ADDENDUM NO. 5

TO: PLANS AND SPECIFICATIONS FOR STATE OF MISSOURI

Renovate Mechanical / Electrical / Life-Safety / State Office Building
Jefferson State Office Building
205 Jefferson Street
Jefferson City, MO 65101
PROJECT NO. O1911-01

1 FIVE PHASE MOVE AND CONSTRUCTION PLAN
G-002

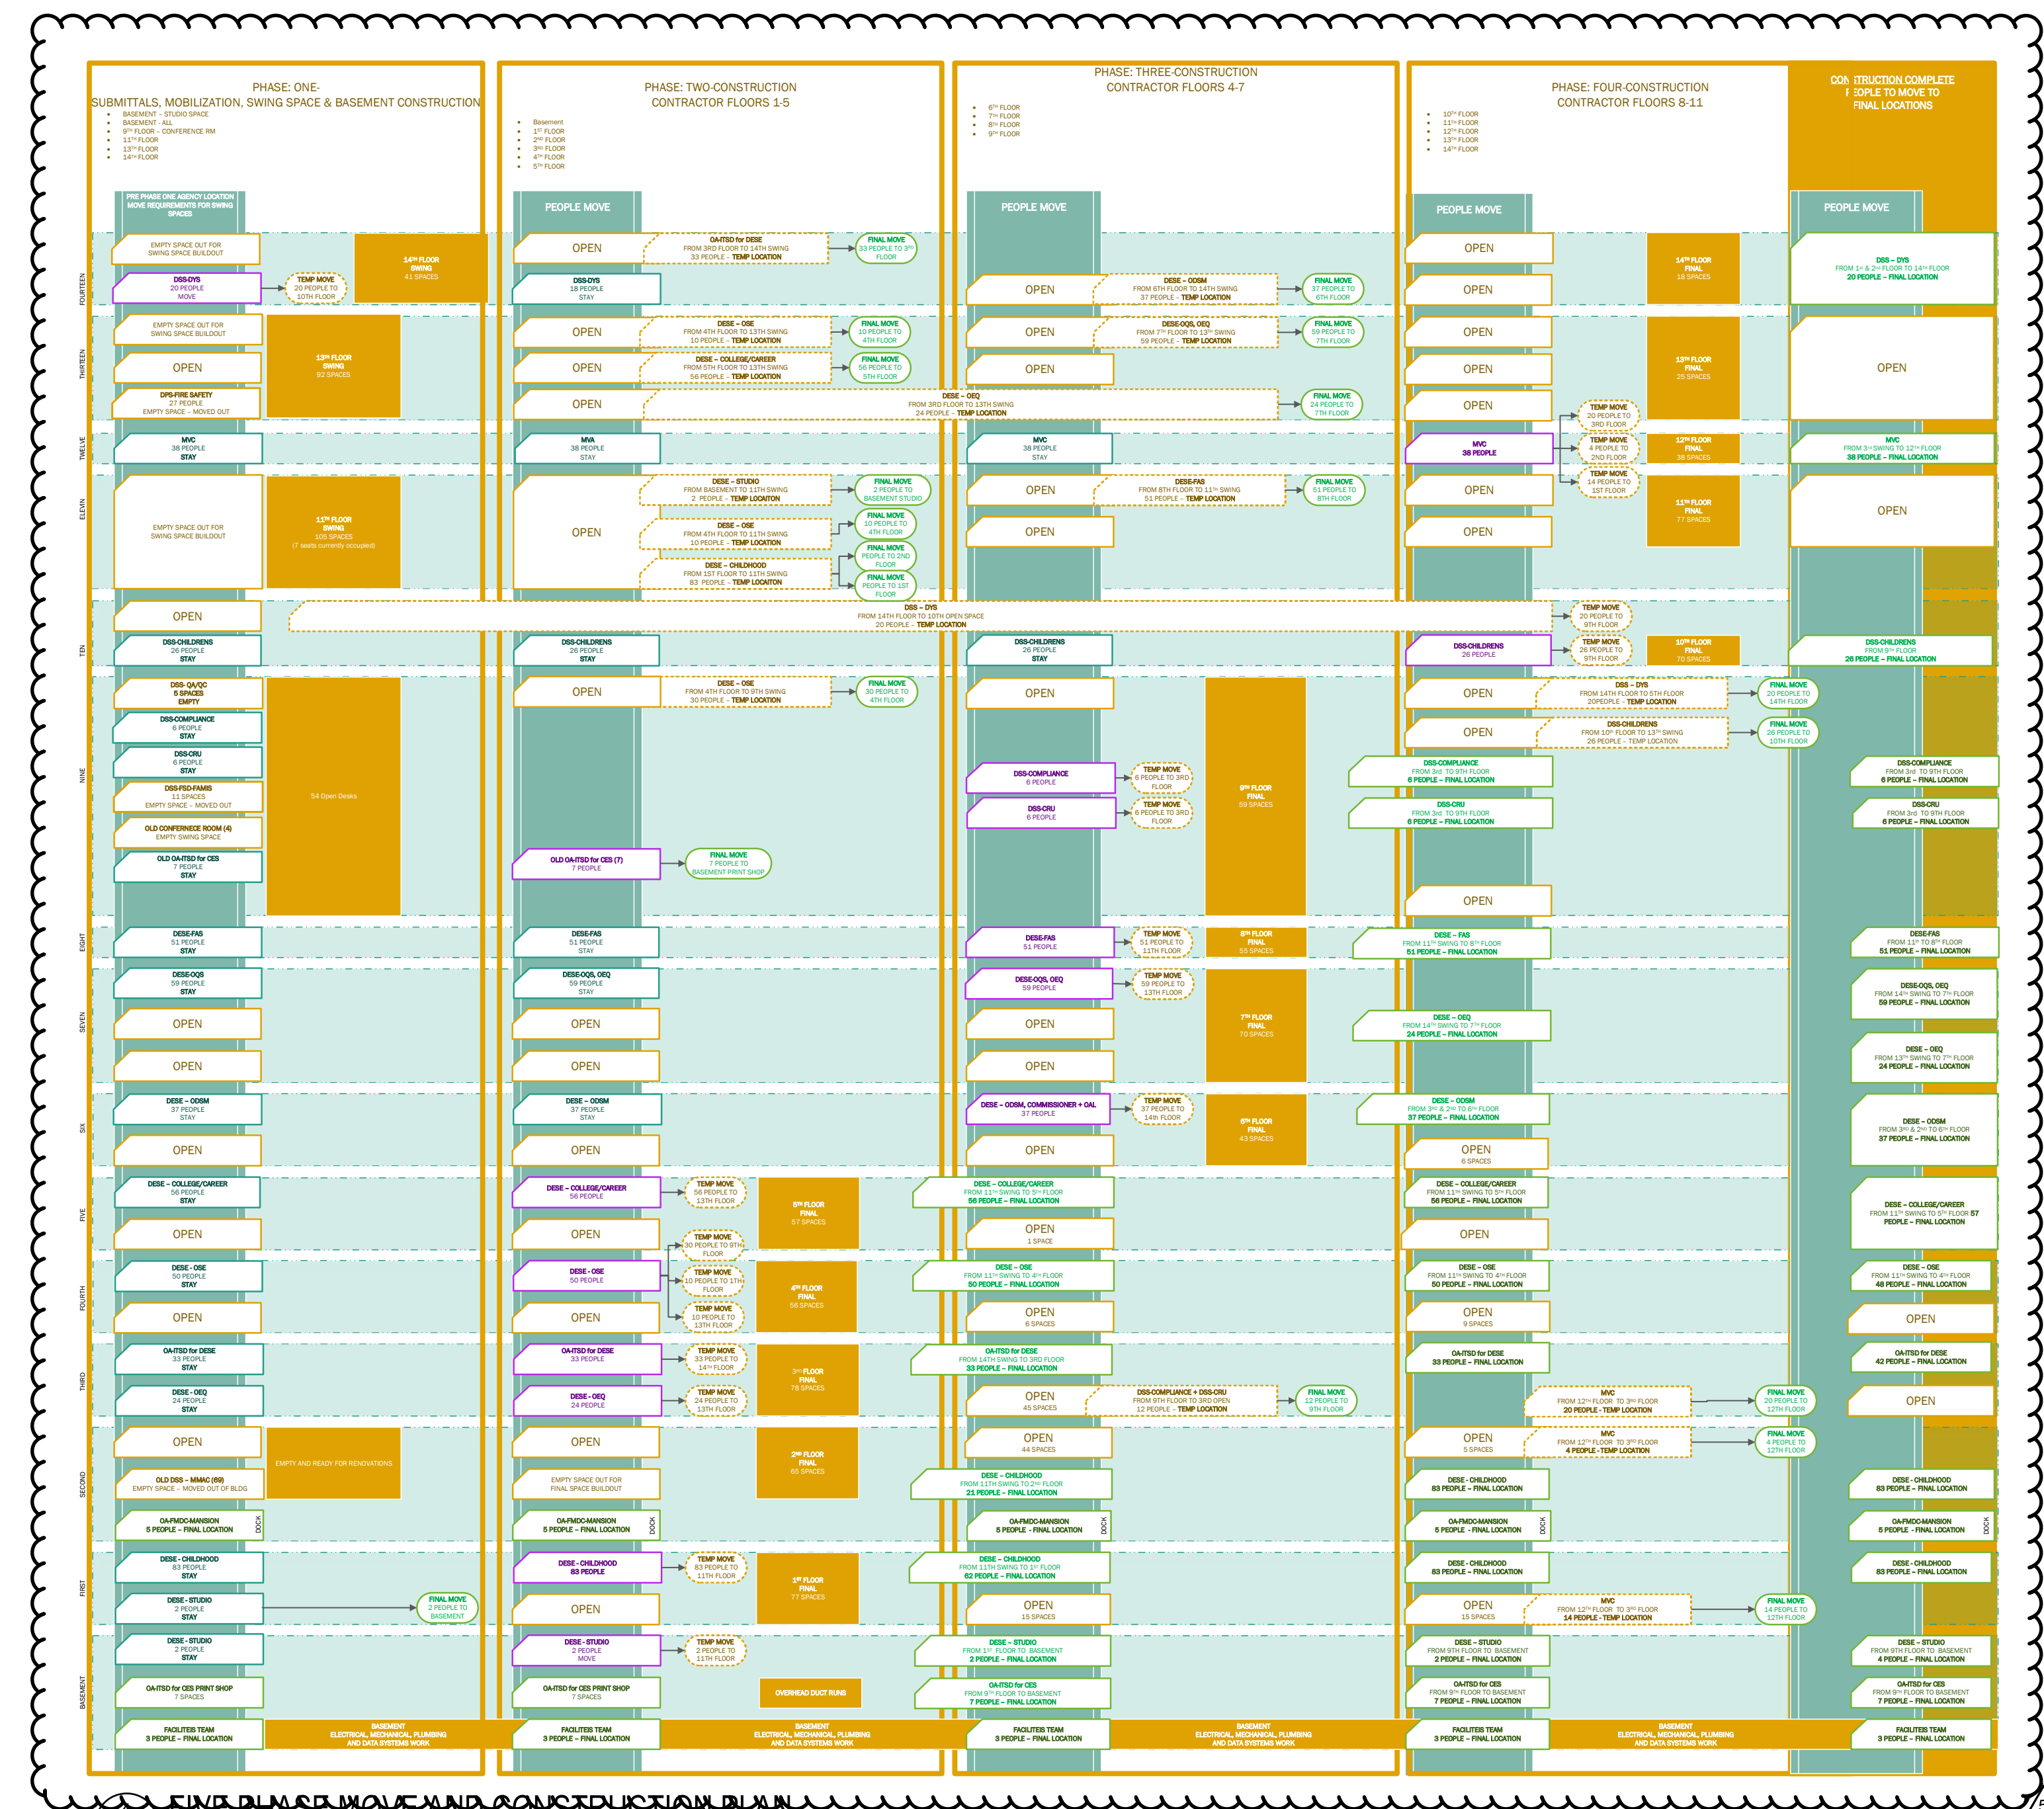
1. Drawing G-002:
 - a. **UPDATED** – People Move Diagram
2. Drawing A-100:
 - a. ADD – Mechanical, Electrical, & Storage areas to scope.
 - b. ADD - Show areas where existing housekeeping pads are to be removed.
 - c. ADD – Demolition Keyed Note D60: REMOVE EXISTING CONCRETE HOUSEKEEPING PAD(S); REFERENCE ARCHITECTURAL SHEETS FOR ADDITIONAL INFORMATION
 - d. ADD – Demolition Keyed Note D61: REMOVE PORTION OF EXISTING CMU WALL TO ACCOMMODATE MECHANICAL DEMOLITION SCOPE (Mechanical Room)

1. Pre-Bid Questions:
 - a. G-002 - Show the Four Phase Schedule instead of the 5 Phase.
Response: See attached sheet G-002 for updated Four Phase Schedule Move Diagram.

- e. How are people moving between floors?
Response: See attached sheet G1 for updated Four Phase Schedule Move Diagram.

SHEET NUMBER:
A-100
23 OF 240
DATE: August 31, 2023

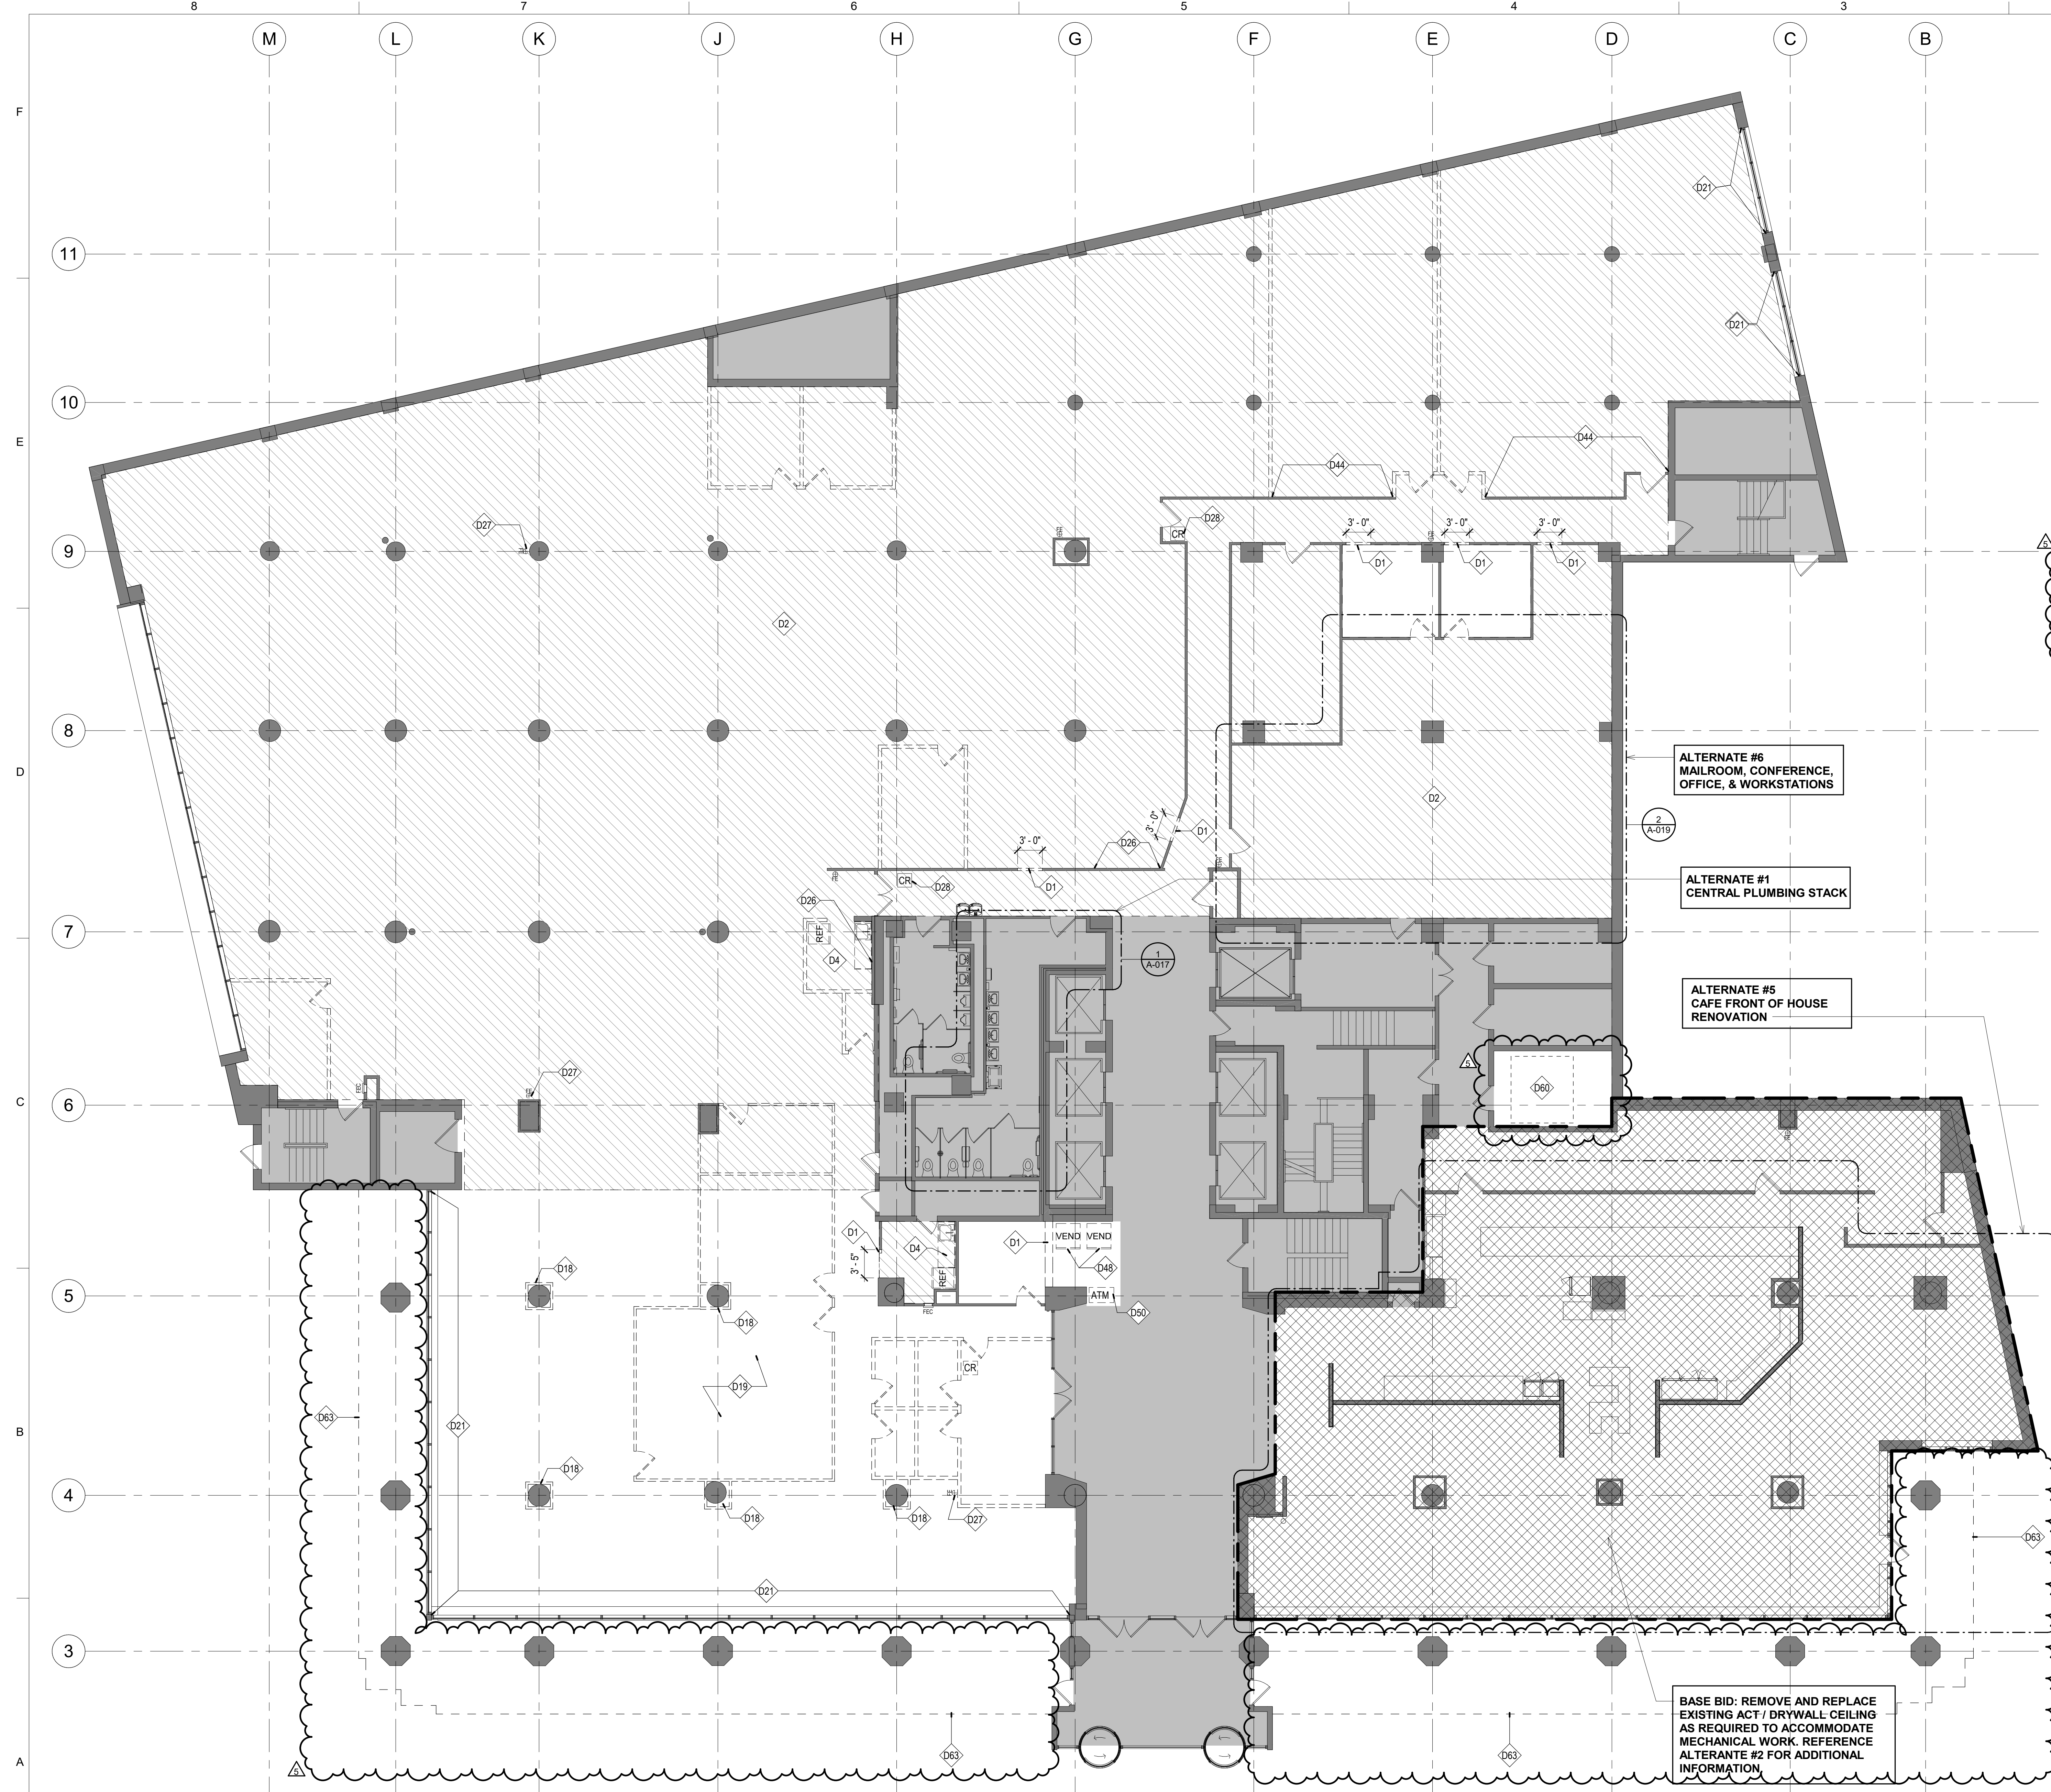
- e. ADD – Demolition General Note 25: FLOORS 2-13: BREAK CAULK AT EXISTING FAN COIL UNIT PLASTIC LAMINATE COUNTERTOPS IN ORDER TO GAIN ACCESS FOR SCHEDULED MECHANICAL WORK.

SHEET TITLE:
DEMOLITION PLAN - 1ST
FLOOR

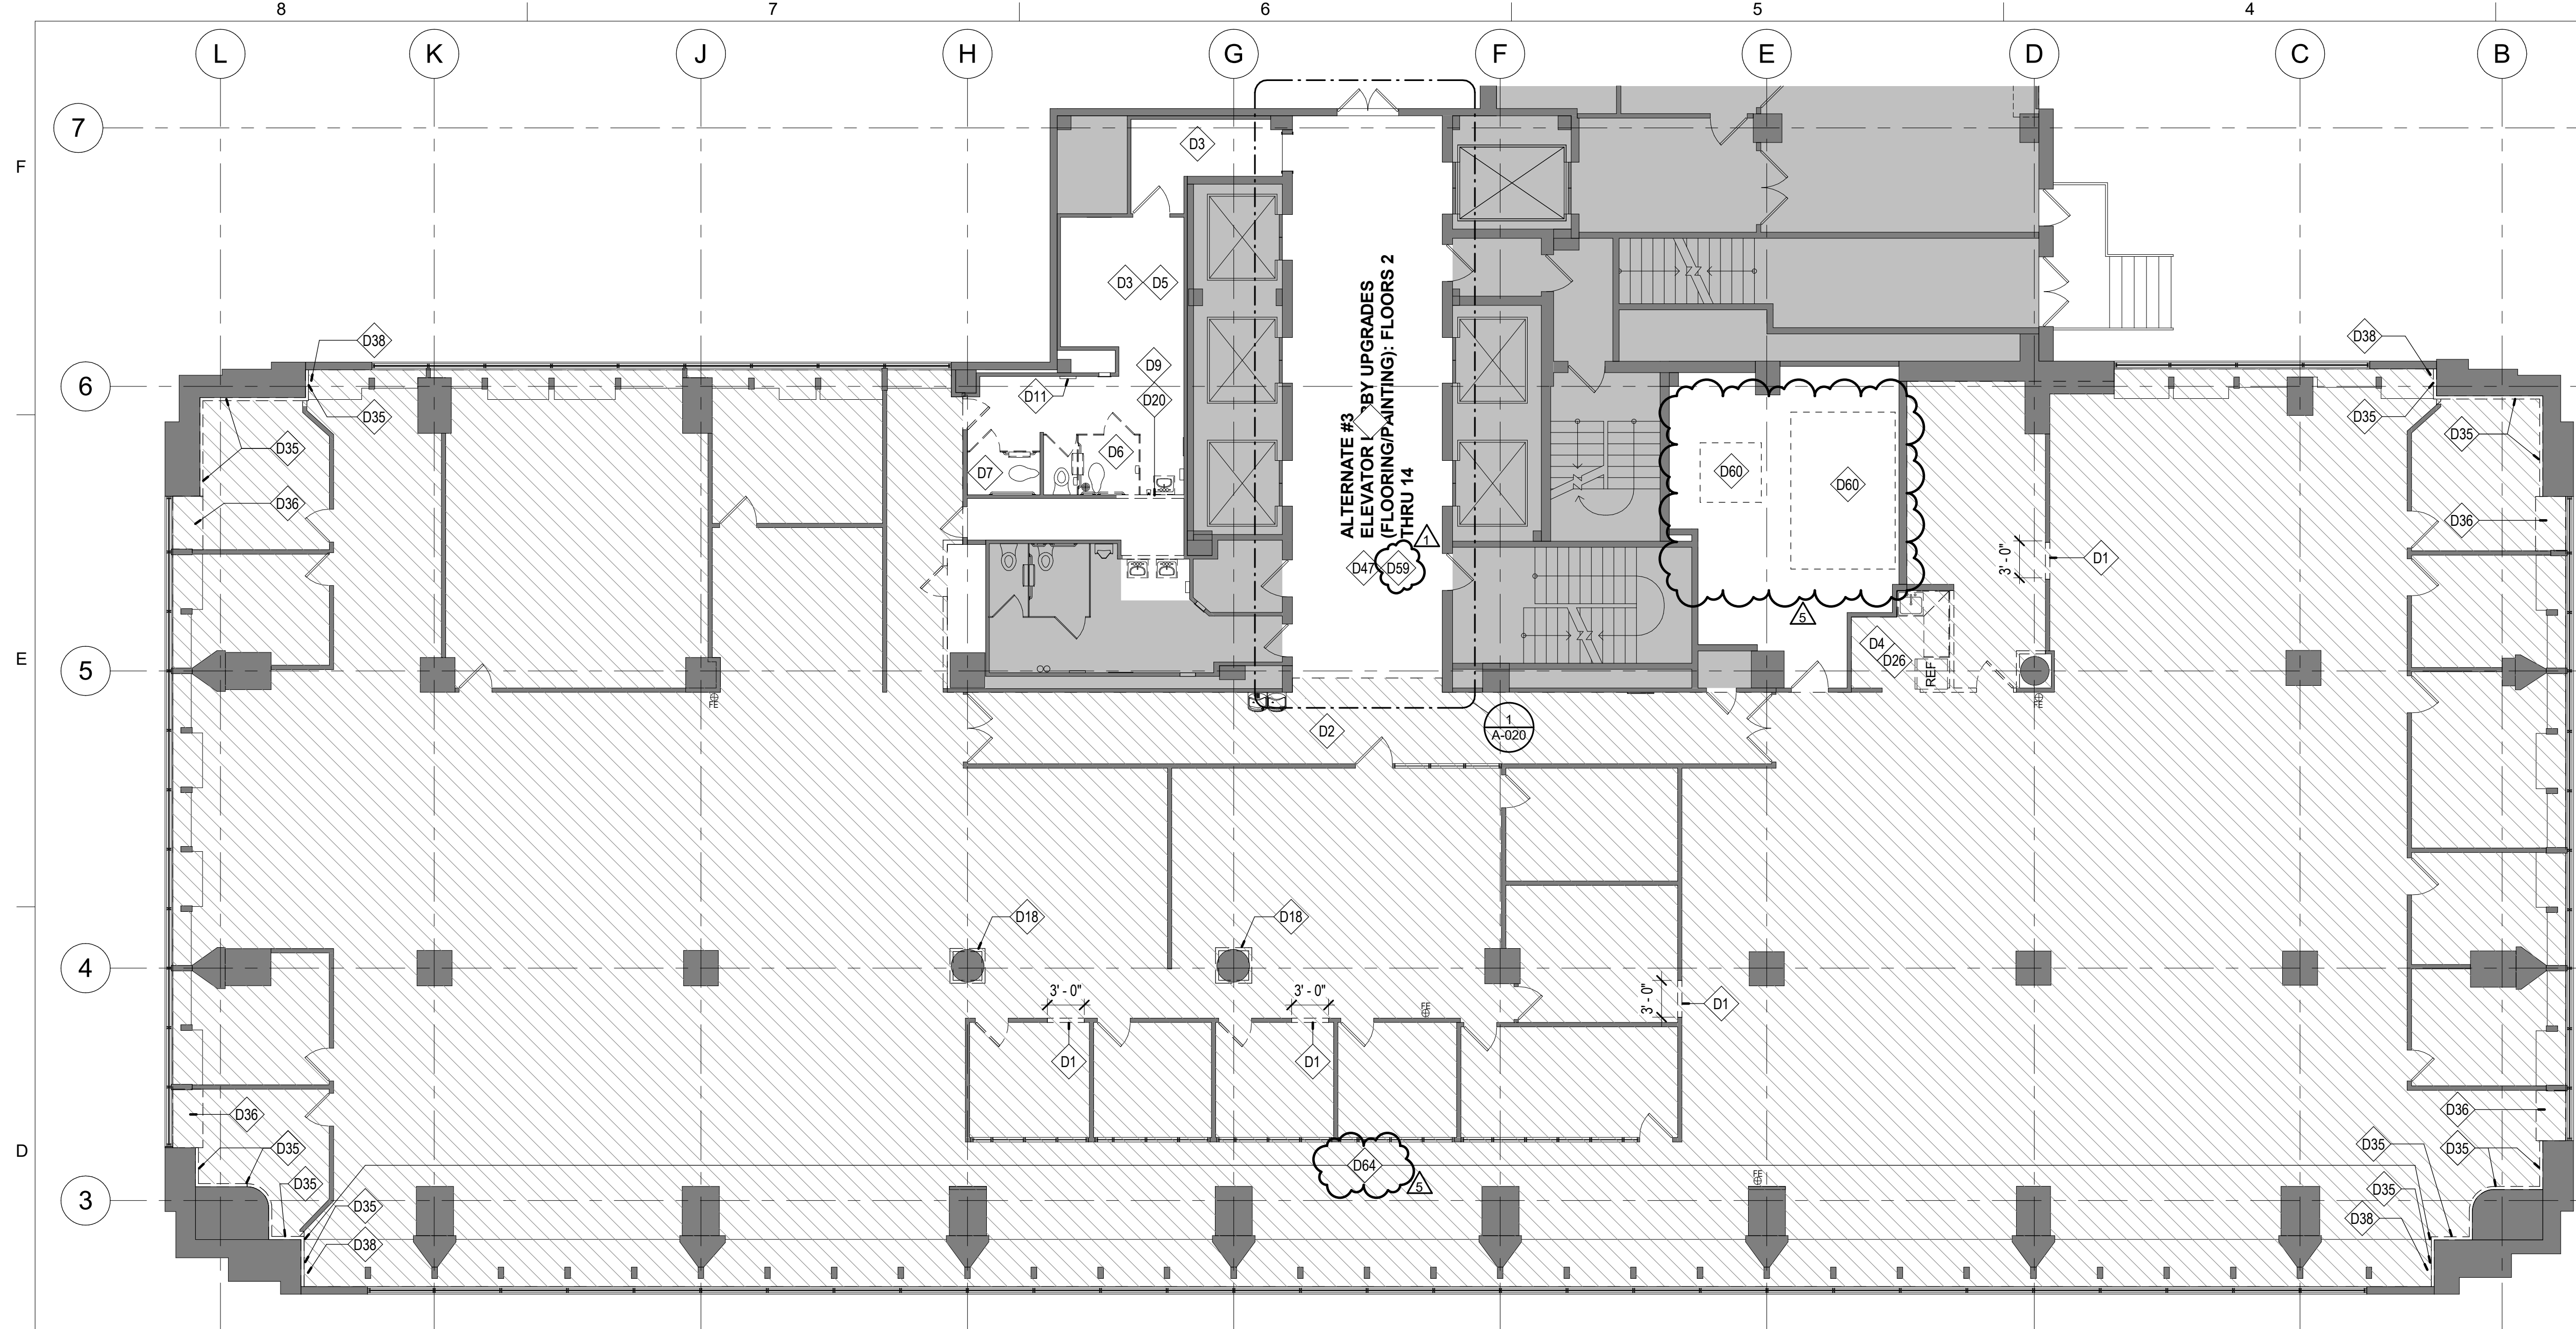
3. Drawing A-101:
 - a. ADD – Soffit overhang at north exterior of building and Demolition Keyed Note D63: DASHED LINE DENOTES SOFFIT OVERHANG ABOVE; REMOVE EXISTING ACCESS PANELS ASSOCIATED WITH MECHANICAL SCOPE AND REINSTALL ACCESS PANELS AFTER WORK HAS BEEN COMPLETED

- b. ADD – Mechanical Room at back-of-house kitchen area to scope and show where existing housekeeping pad is scheduled to be removed (Demolition Keyed Note D60).
